Access Compliance Report

Public Rights-of-Way

(Curb Ramps)

Intersection ID: 22310	Main Street: OAK_CREEK_DR	Cross Street: SARDIS_RD	Location: W
ADA ID: 15E5EC896616	Ramp Type: PerpDiag	Initial Pass/Fail: Fail	Overall Compliance: No
Severity Score: 46.25			
Codes/Mitigation Info/Possible Solution		Field Measurements/Component Compliance

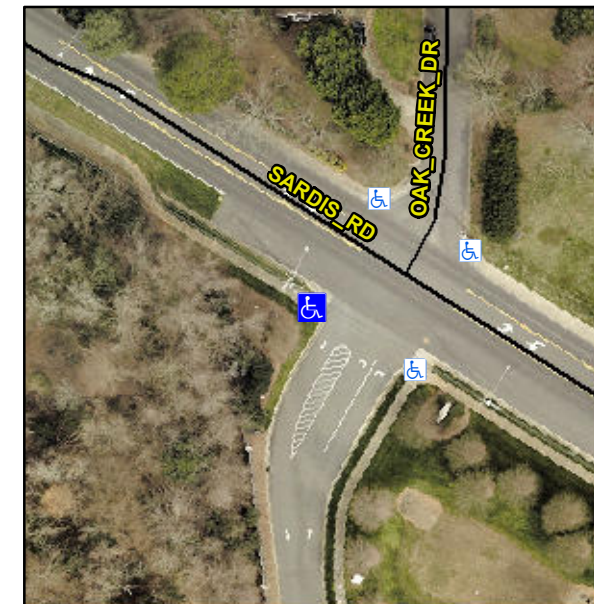
Not Found, R304.5.1, R304.2.2, R304.5.3

Compliance	Description	Data	Compliance	Description	Data
N/A	Ramp Length (in)	60.0	No	Ramp Slope (%)	15.3
No	Ramp Width (in)	38.0	No	Ramp XSlope (%)	5.2
N/A	Flare Type LT	N/A	N/A	Flare Type RT	N/A
N/A	Flare Slope LT (%)	N/A	N/A	Flare Slope RT (%)	N/A
N/A	Flare Traversable LT?	N/A	N/A	Flare Traversable RT?	N/A
N/A	Landing Length (in)	N/A	N/A	DWS Provided?	N/A
N/A	Landing Width (in)	N/A	N/A	DWS Contrast?	N/A
N/A	Landing Slope (%)	N/A	N/A	DWS Length (in)	N/A
N/A	Landing X Slope (%)	N/A	N/A	DWS Full Width?	N/A
N/A	Landing Curb? (Y/N)	N/A	N/A	DWS Offset (in)	N/A
N/A	Shared Landing?	N/A			
N/A	Gutter Ponding?	N/A	N/A	Gutter Slope (%)	N/A
N/A	Gutter Lip Ht (in)	N/A	N/A	Gutter X Slope (%)	N/A
N/A	Painted X Walk1?	No	N/A	Painted X Walk2?	No
	X Walk 1 Direction	To SE		X Walk 2 Direction	To NE
N/A	X Walk 1 Width (in)	N/A	N/A	X Walk 2 Width (in)	N/A
	X Walk 1 Slope (%)	5.3		X Walk 2 Slope (%)	10.6
	X Walk 1 X Slope (%)	6.1		X Walk 2 X Slope (%)	0.8

N/A	Ramp inside XWalk1?	N/A	N/A	Ramp inside XWalk2?	N/A
	Road Slope (%)	6.3	N/A	Clear Space?	N/A
	Road X Slope (%)	3.1	N/A	Clear Space to XWalk (in)	N/A
N/A	Any Obstructions?	N/A	N/A	Storm Grate/Utility Hazard?	N/A
	Obstruction Type			Storm Grate/Utility Type	
		N/A			N/A
			Yes	Surface Condition? (G/P)	Good

Remove & Replace Curb Ramp With Two New Directional Ramps or Equivalent.
